Appendix C

*Tribal Agency Position
Supporting Materials*

C1 INTRODUCTION

Appendix C contains Tribal Cooperating Agencies' comments and supporting documentation that represent major differences of opinion with the analyses as presented in the SDEIS. The information was submitted by the Bois Forte, Grand Portage, Fond du Lac, Great Lakes Indian Fish & Wildlife Commission, and the 1854 Treaty Authority. All materials in this appendix are Tribal views provided verbatim and have not been validated or approved by the Co-lead Agencies.

Figure 1: Analog Drawdown Contours in Relation to Proposed NorthMet Pits

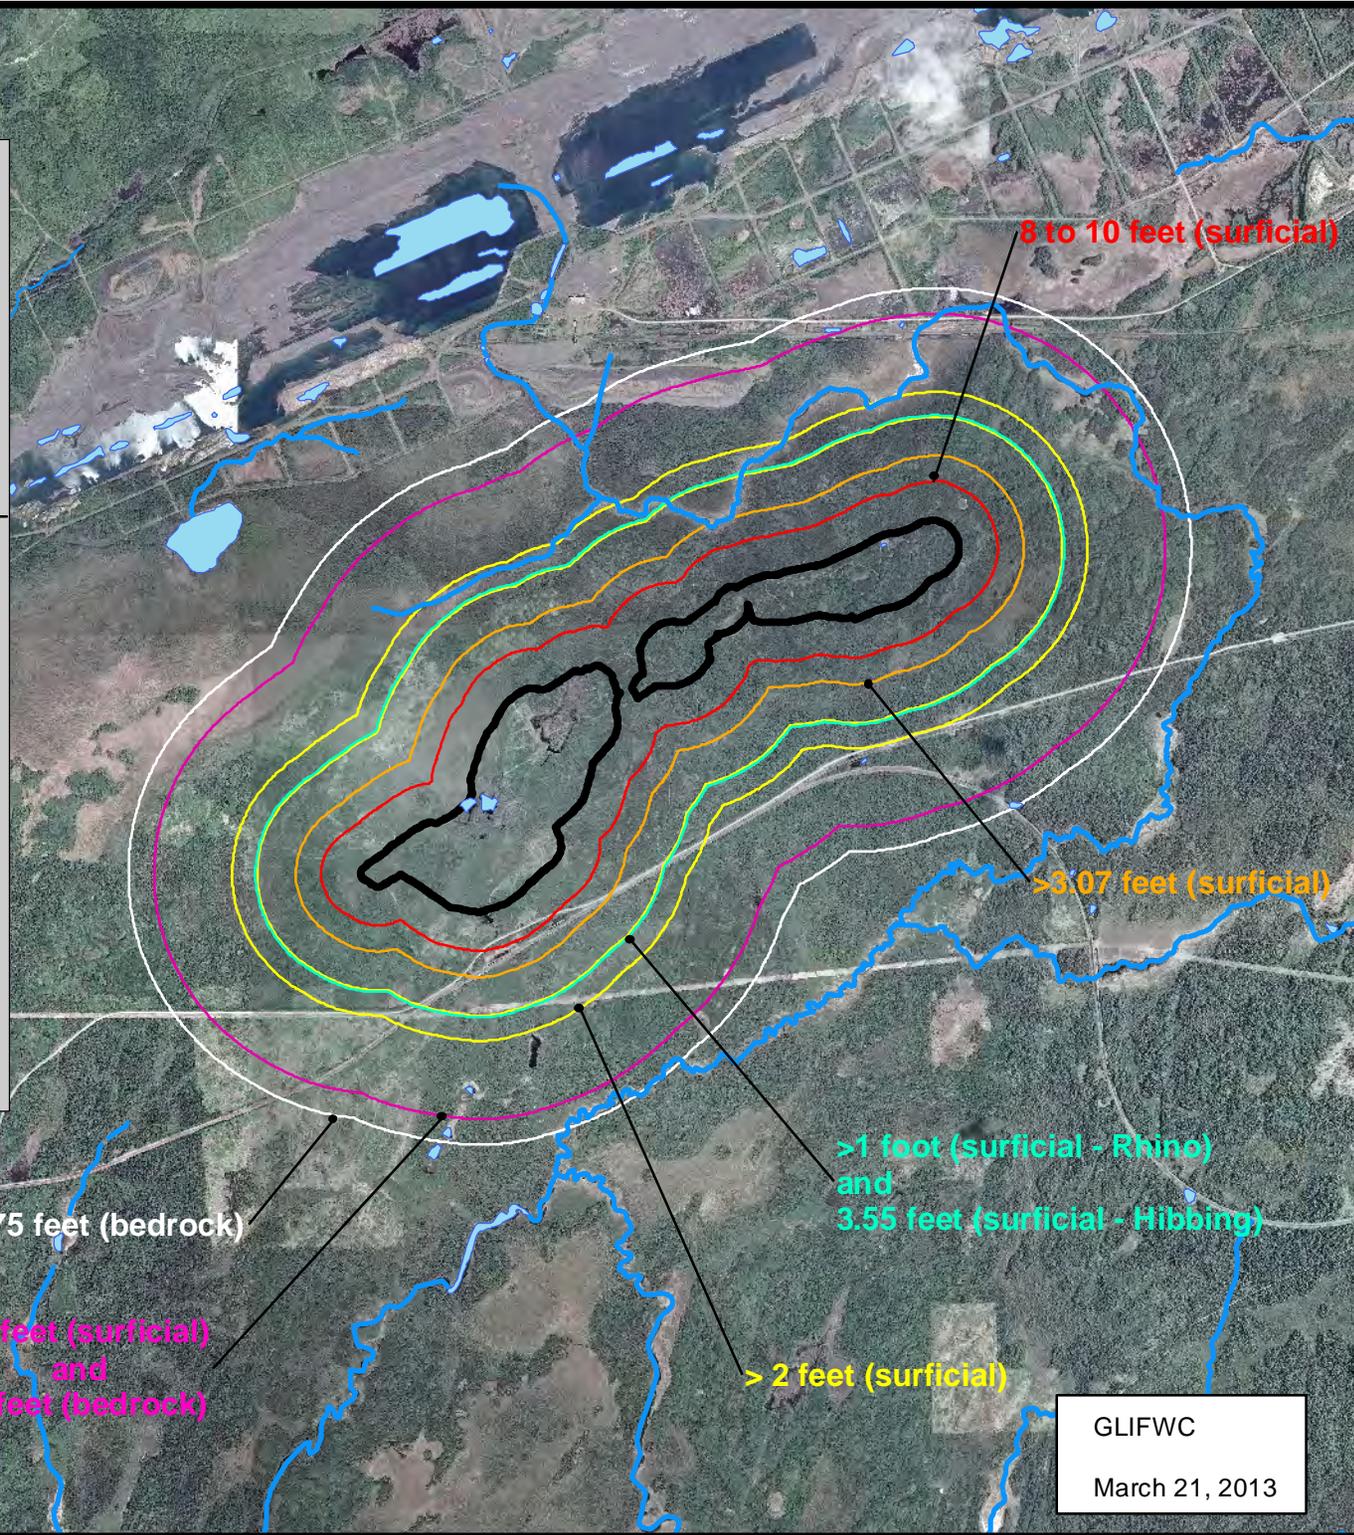
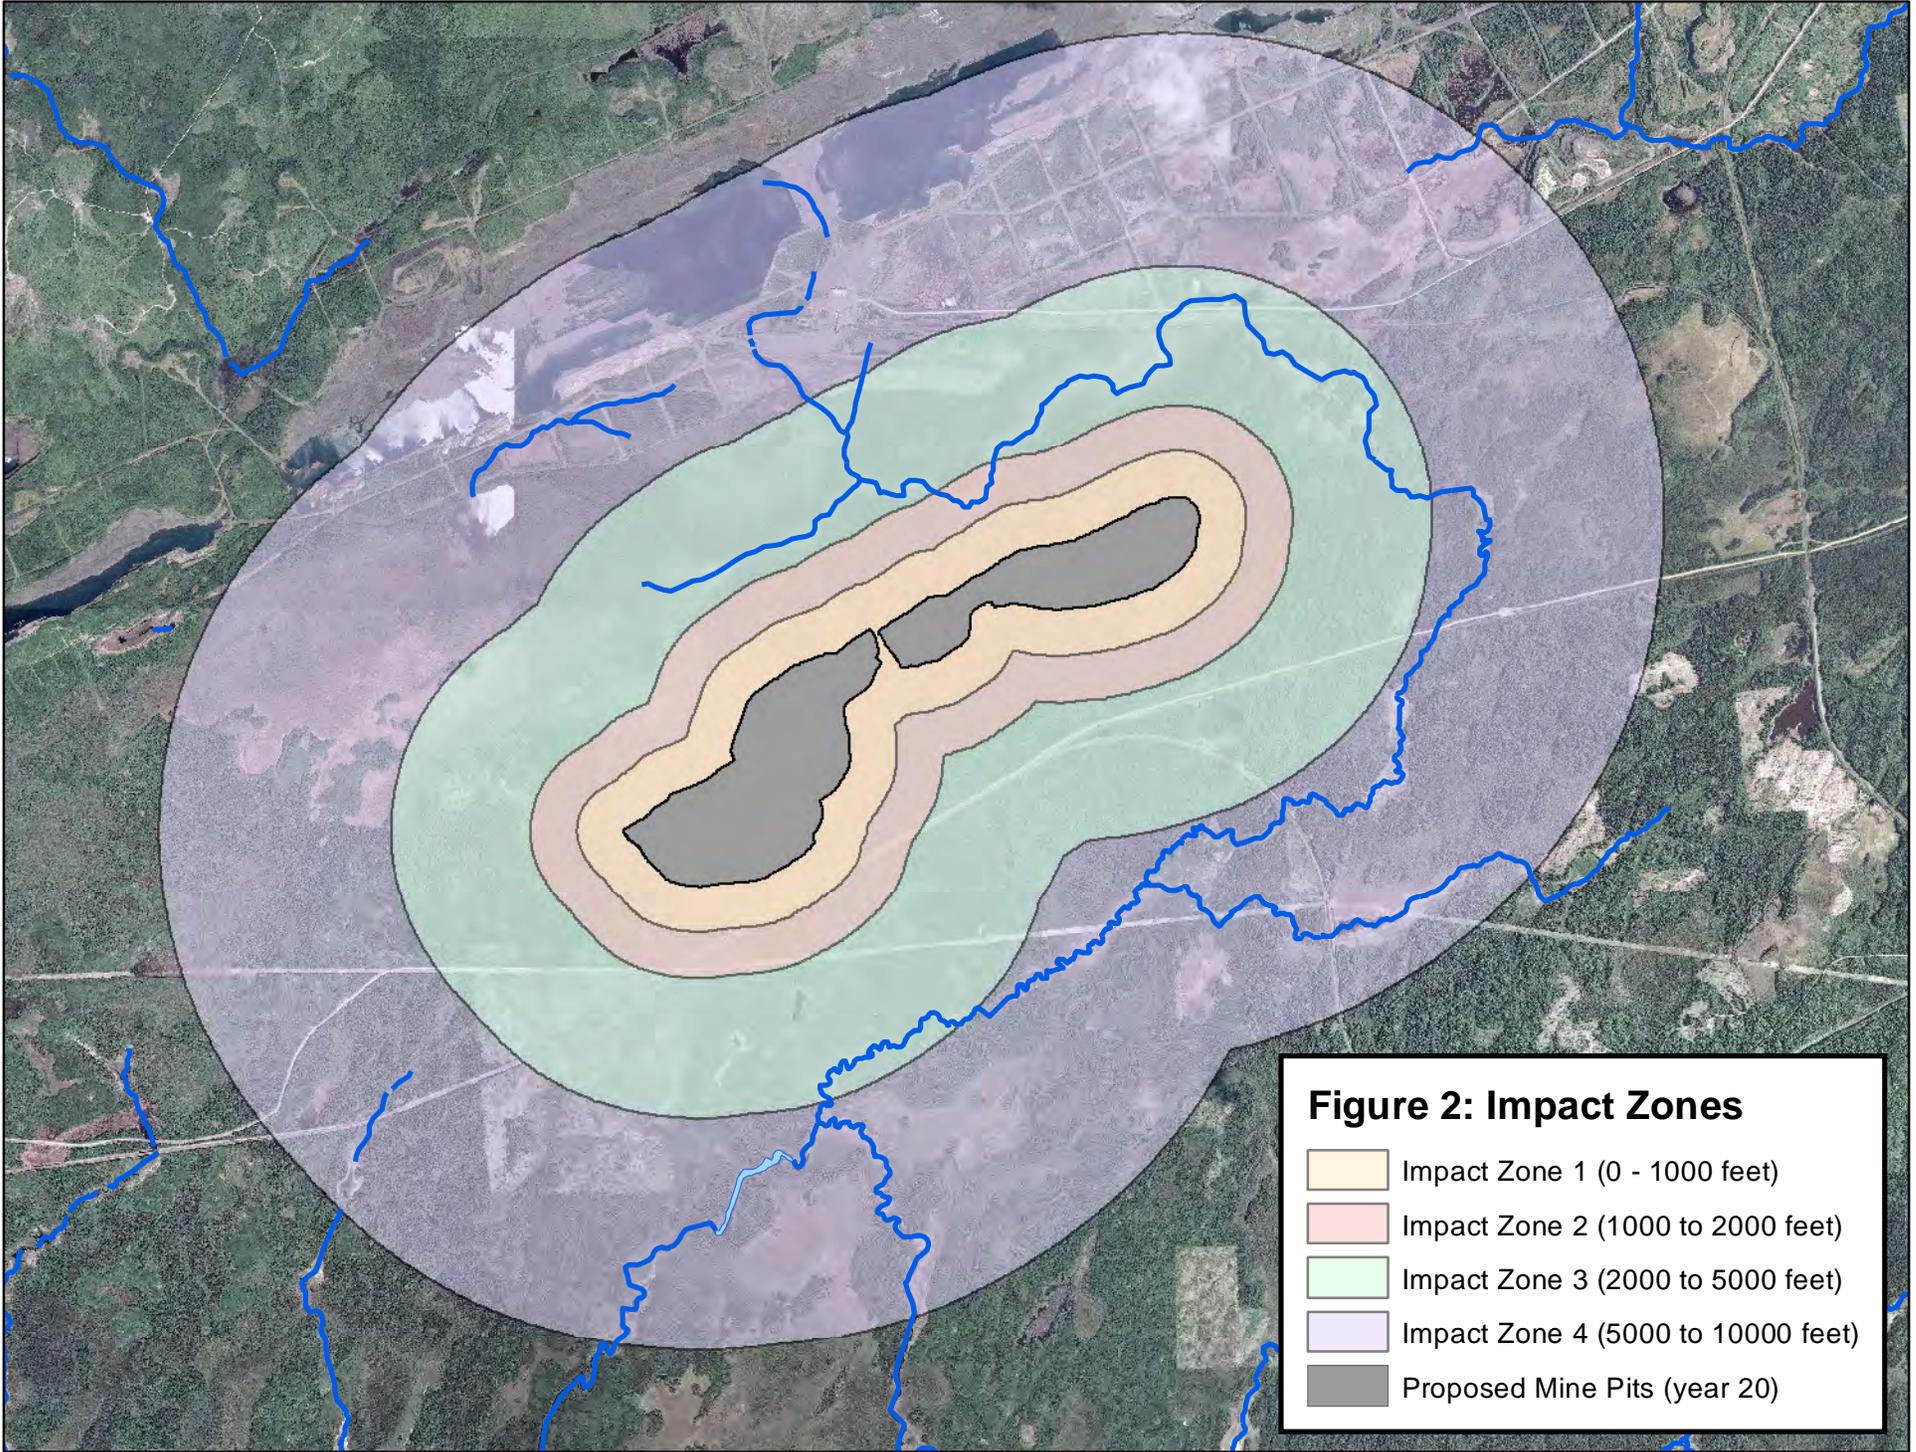
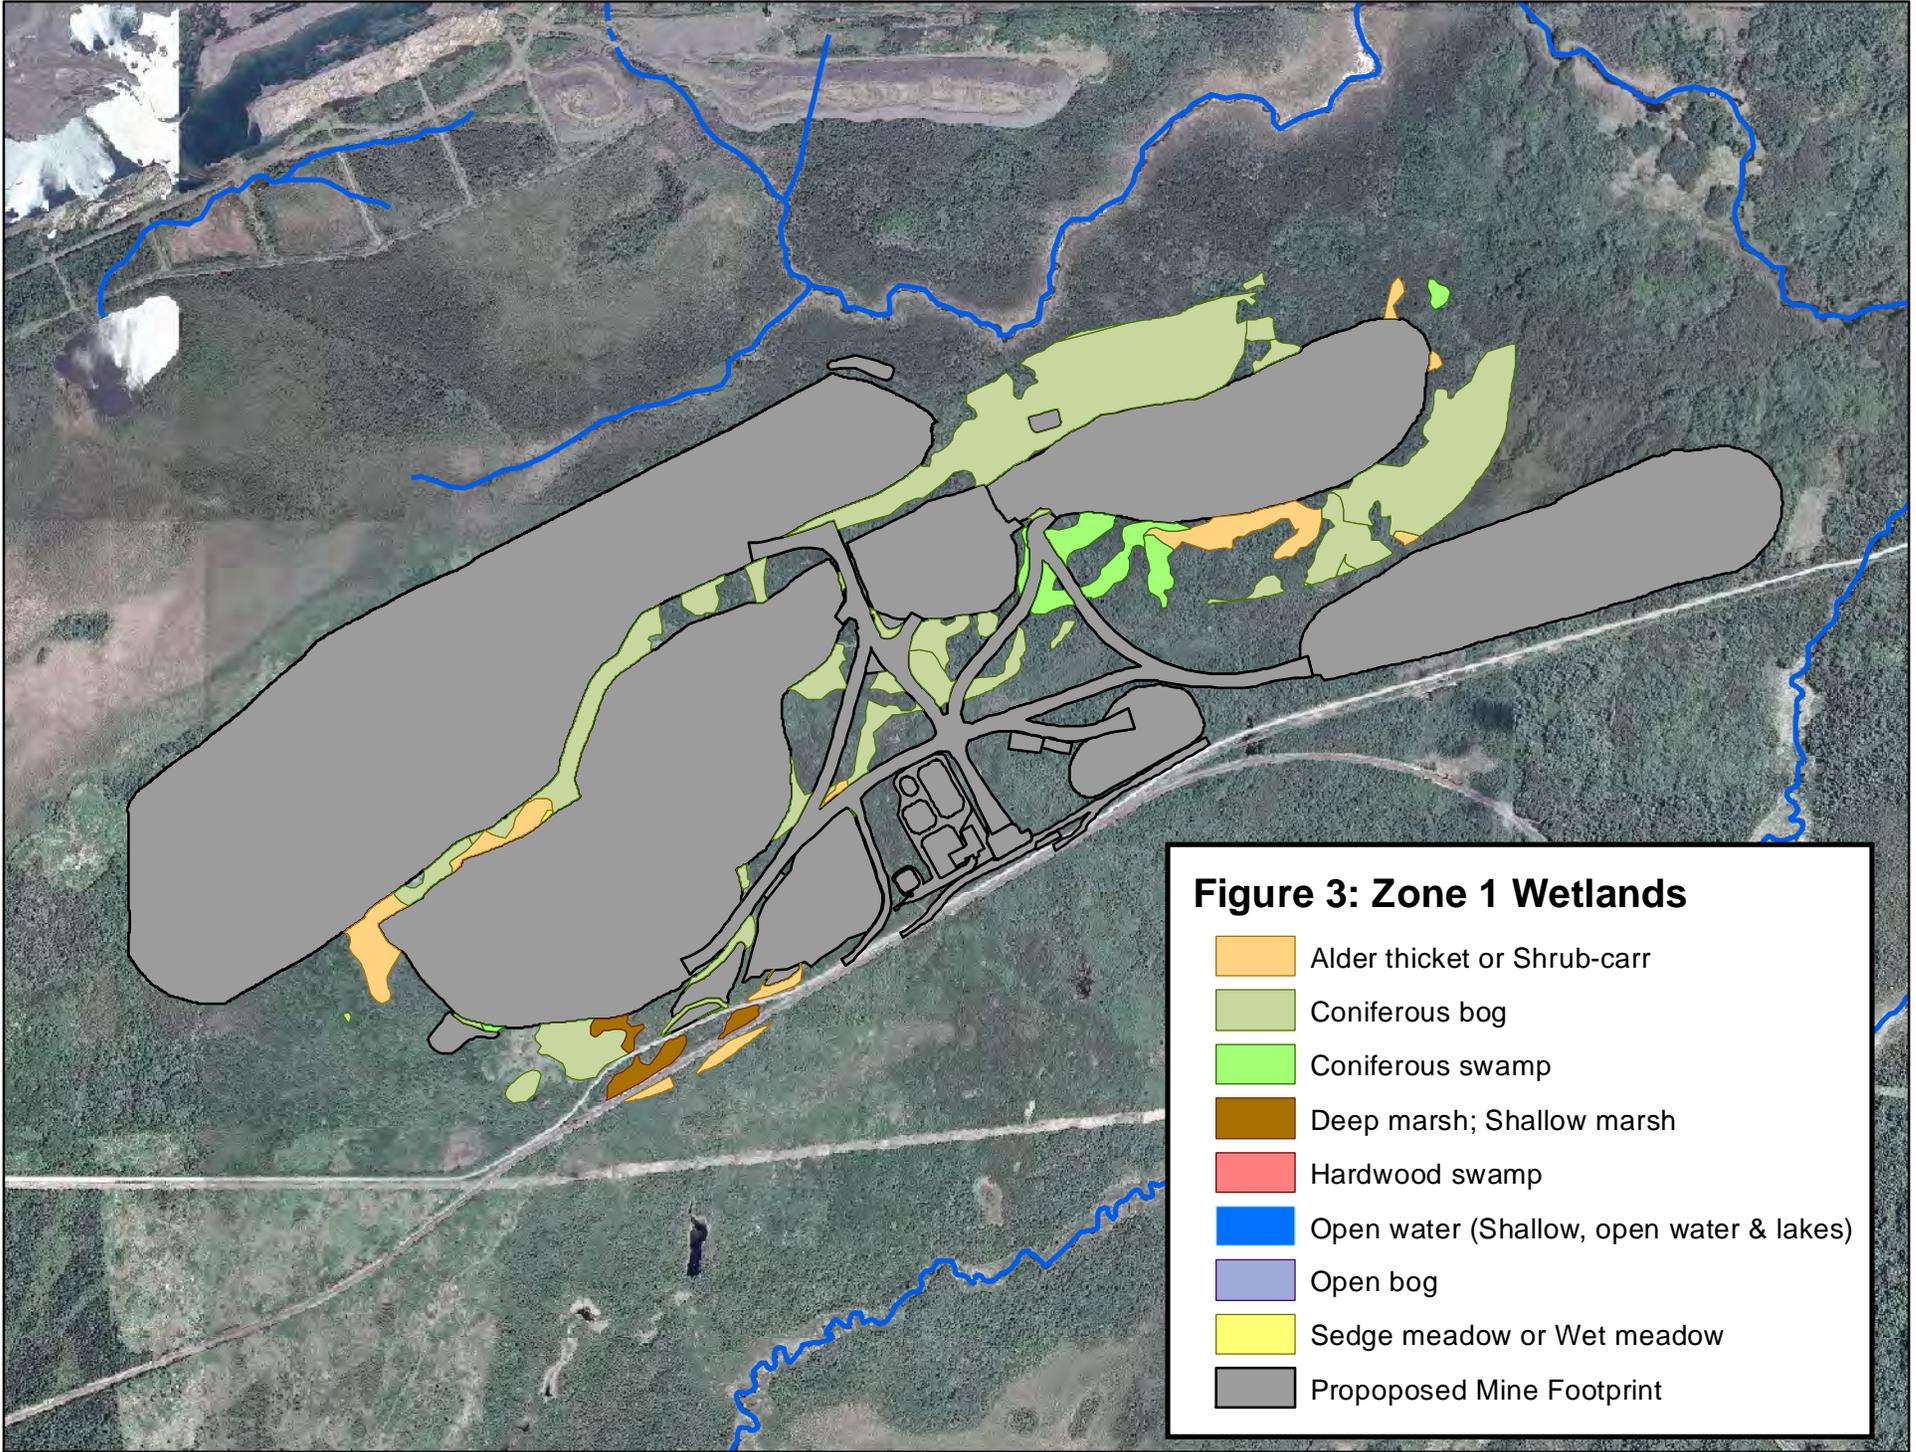
Contour lines showing the analog well information in relation to the proposed NorthMet mine site are provided in Figure 1.

Based on GLIFWCs analysis, wetlands severely impacted by drawdown total 3188.62 acres in zone 1; 2458.12 acres in zone 2; and 273.01 acres in zone 3. Severe indirect impacts to wetlands from mine pit drawdown total 5719.75 acres. All wetlands potentially impacted by drawdown are depicted in Figure 9. The Corps should require up front mitigation for all severely impacted wetlands. At a minimum, up front mitigation for all wetlands in zone 1 should be required. Additional up front mitigation should be considered for wetlands that are classified in the moderate to severe category. Robust monitoring is required for wetlands in the moderate category.

Figure 23. Annual Maximum of Concentration Statistics: Chloride at the North Toe.

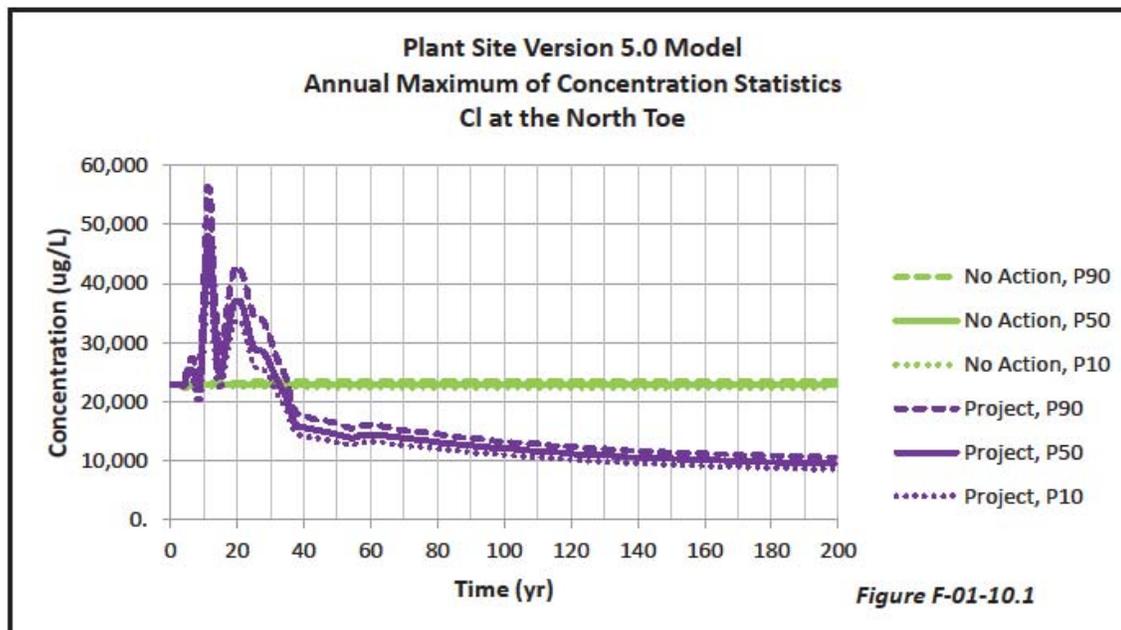
Based on the above CEQ guidelines, it is clear that activities that will occur under the Cliffs Consent Decree should be included in modeling of a No Action alternative. Unfortunately not only are the consent decree activities not included, but the fact that it will be precipitating on the tailings basin for the foreseeable future has not been included in the No Action modeling. This is evident by the model results that show stable levels of chloride coming from the basin for the next 200 years (Figure 23) when there is no ongoing source for chloride. With no source for new chloride, rainwater will gradually dilute the residual chloride in the basin and levels will drop. The PSDEIS claims that the basin's water quality has stabilized and that the current conditions will not change over time. The claim of chemical stability is based on basin pond water sampling for only 4 years (2001 – 2004, PSDEIS Table 4.2.2-23).

Since there has been no water quality data collected in the basin pond for 9 years it is reasonable to assume that the past 9 years of precipitation has diluted the water chemistry in the basin pond, and that eventually the more dilute water will percolate through the basins and be discharged at the toe. If chemical stability is to be assumed, more recent data on basin pool water chemistry is needed. While the CEQ makes it clear that a blind "continuation of existing conditions" model is inappropriate as a No Action alternative, a "continuation of existing conditions" model that ignores simple environmental processes such as precipitation is even less appropriate.
